**Southeast Planning Review and Adjustment Committee /
Comité de révision de la planification de la Commission du Sud-Est**

Staff Report / Rapport du personnel

Subject / Objet : recommendation to the minister for the location of new public streets

File number / Numéro du fichier 21-1095

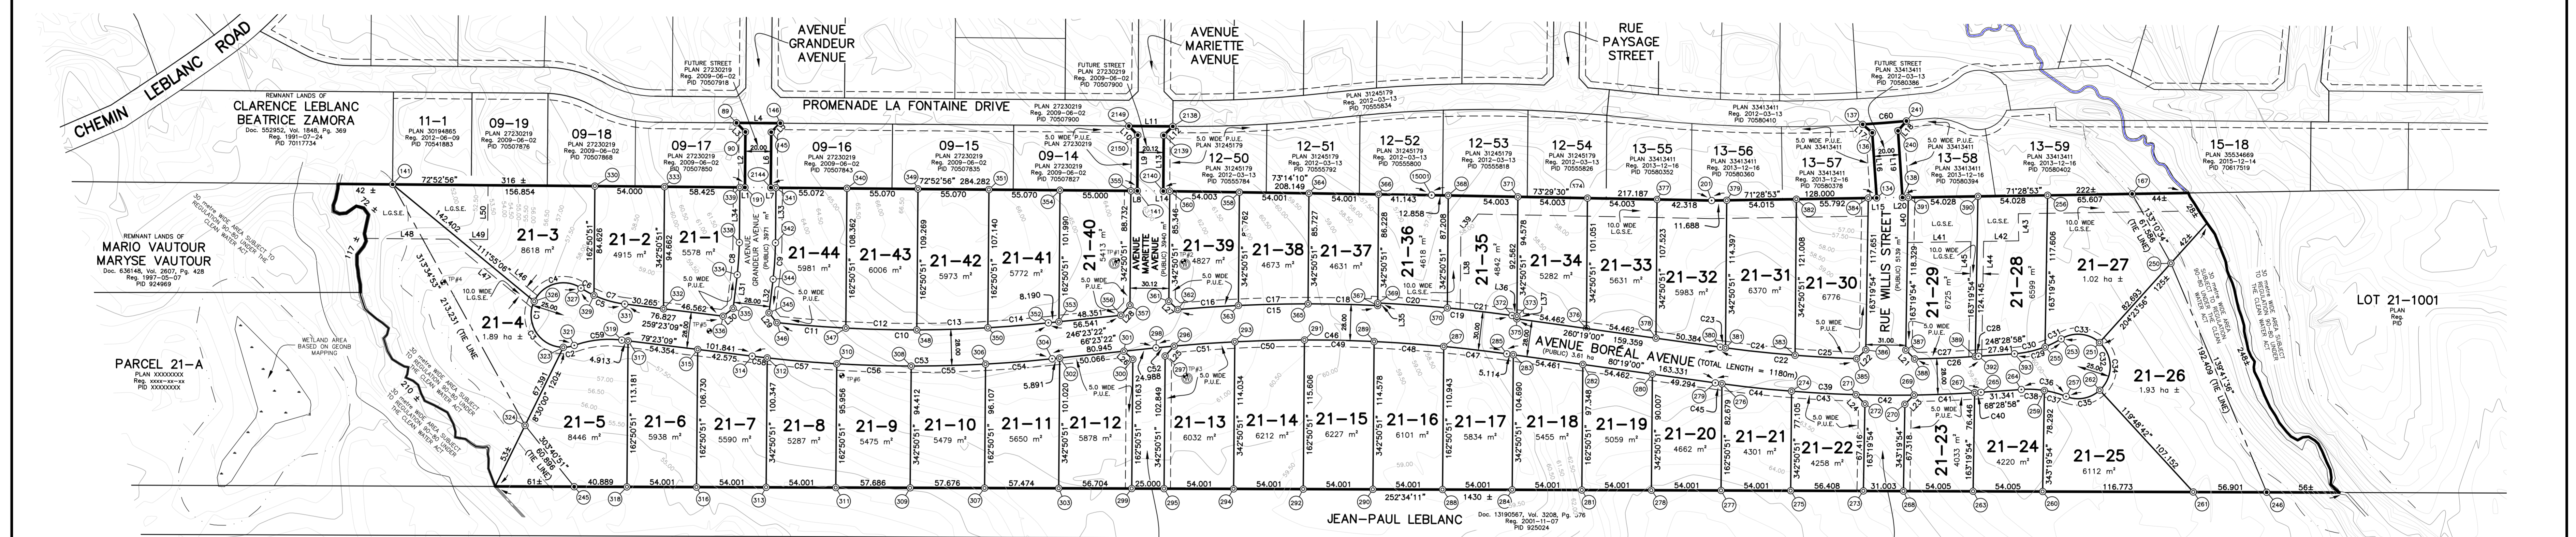
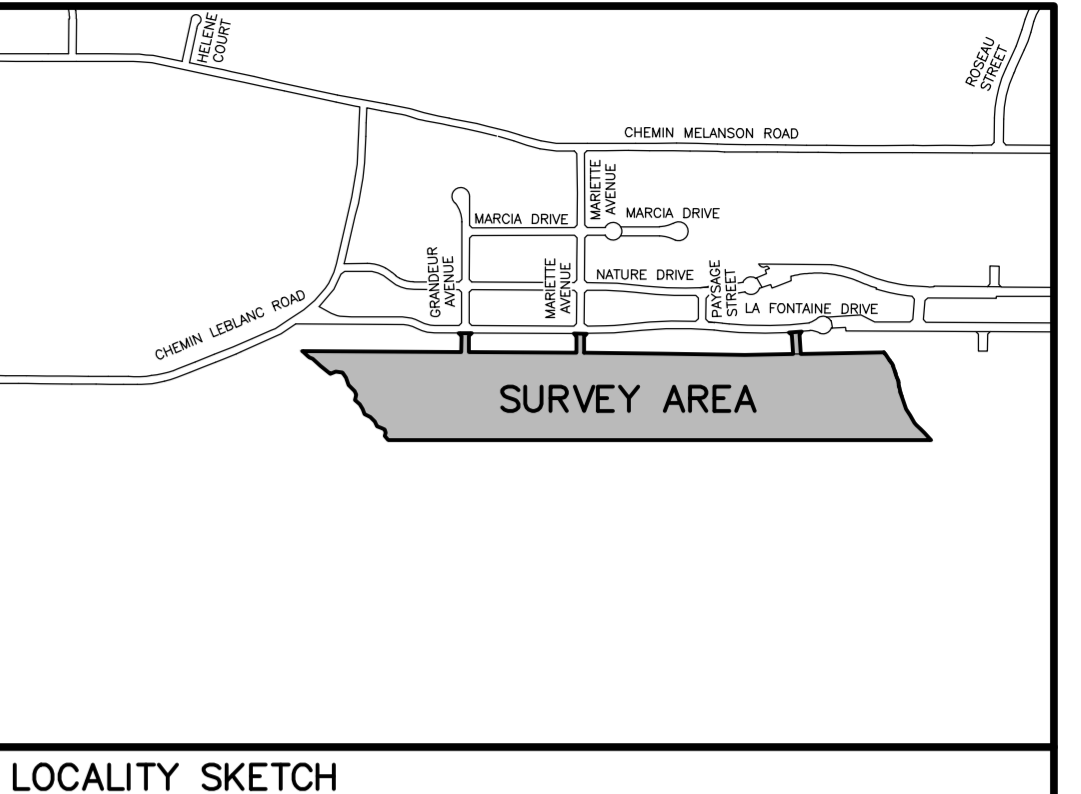
The location of the proposed street(s) shown on the tentative subdivision plan mentioned above is acceptable to the Department of Transportation and Infrastructure.

- The developer is required to submit a street design including a plan and profile and cross sections showing top and bottom of foreslopes and backslopes, direction of ditch flow, pipe sizes, Local Government Services Easements and street right-of-way width for the proposed streets. The design drawings must be prepared and stamped by a registered Professional Engineer of New Brunswick and submitted to the Department prior to the Minister signing the final plan.

- The drainage system shall be designed to consider the drainage basin as a whole and must accommodate not only runoff water from the subdivision area but also, where applicable, the system shall be designed to accommodate the runoff water from those areas adjacent to and upstream from the subdivision itself, as well as its effects on lands downstream. It is the developer's responsibility to determine how the run-off water from the lots and the proposed public streets will be carried away to ensure that it does not have a negative effect on the proposed lots and the existing properties in the area. A detailed drainage report must accompany the drainage plan in order to evaluate the drainage pattern. Where environmental permits are required, copies should be forwarded to the Department of Transportation and Infrastructure. Prior to the Minister signing the final plan, stamped copies of the engineered drainage study and design shall be forwarded to the Department.

- The developer shall provide "Local Government Services Easements" with a 10-m minimum width for all drainage ditches crossing the proposed lots and the remnant property that are intended to drain water to and away from the street ditches in the proposed development. The minimum grade for drainage ditches is 1.0%.

- The right-of-way limits at the proposed street intersection(s) shall be laid out as shown on "Figure A10" of the Minimum Standards.
- A suitable turning area must be constructed at the end of any temporary dead-end street created by developing the subdivision proposal in phases. The temporary turnaround must meet the requirements shown in "Figures A4 or A5" of the Minimum Standards.

- Additional street right-of-way allowance will be necessary where the topography of the land or the soil type requires extra width for deeper or wider ditches. The street right-of-way may have to be widened to more than the minimum 24 metres in some areas to ensure that the ditch and the backslope/foreslope are within the area to be vested in the Crown as a public street. The additional street right-of-way width will be necessary for future street maintenance activities. Standard survey markers shall not be placed in the ditches.

- The street(s) shall be constructed so that there are acceptable sight distances at all driveway accesses and street intersections as per 4.3.7 of the Minimum Standards.
- The turn(s) along the proposed street(s) shall be designed as curves as specified in "Section 5.2.1" of the Minimum Standards. The back-to-back curves shall be separated by a minimum tangent length of 15 m as specified in the Urban Supplement to the Geometric Design Guide for Canadian Roads produced by the Transportation Association of Canada.

Staff respectfully recommends that the Southeast Planning Review and Adjustment Committee **recommends** that the Minister of Transportation and Infrastructure assent to the location of Grandeur Ave, Mariette Ave, Sillis street, and Boréal ave as shown on the Domaine Boréal Subdivision plan. / *Le personnel recommande respectueusement que le Comité de révision de la planification du Sud-Est **recommande** que le ministre des Transports et de l'Infrastructure approuve l'emplacement de l'avenue Grandeur, Mariette, et Boréal, ainsi que la rue Willis tels que montrés sur le plan de lotissement Domaine Boréal*

1. The development officer shall not approve the final subdivision plan until all conditions as outlined by the Provincial Department of Transportation and Infrastructure letter from Mr. Paul Lightfoot to Mr.Phil Robichaud Dated August 19, 2021, have been satisfied. / *L'agent de développement ne doit pas approuver le plan de lotissement définitif avant le respect de toutes les conditions décrites dans la lettre du ministère provincial des Transports et de l'Infrastructure envoyée à M. Phil Robichaud par M. Paul Lightfoot le 19 août, 2021*

2. To caution future lot purchasers the following note shall be placed on the final subdivision plan as follows; "Based on a Hydrogeological Study conducted by Craig Hydrogeologic, dated March, 2021, a residential water treatment unit may be required to ensure water quality within the Guidelines for the Protection of Canadian Drinking Water Quality." / *Il faut ajouter la remarque suivante sur le plan de lotissement définitif afin d'avertir les acheteurs futurs de lots : « En fonction d'une étude hydrogéologique réalisée par Craig Hydrogeologic (en date de mars 2021), un système de traitement d'eau résidentiel peut être requis pour assurer la qualité de l'eau conformément aux Recommandations pour la qualité de l'eau*

3. A soil assessment report shall be sent to the development officer prior to the final plan endorsement. / *Il faut envoyer un rapport d'étude du sol à l'agent de développement avant l'approbation définitive du plan.*
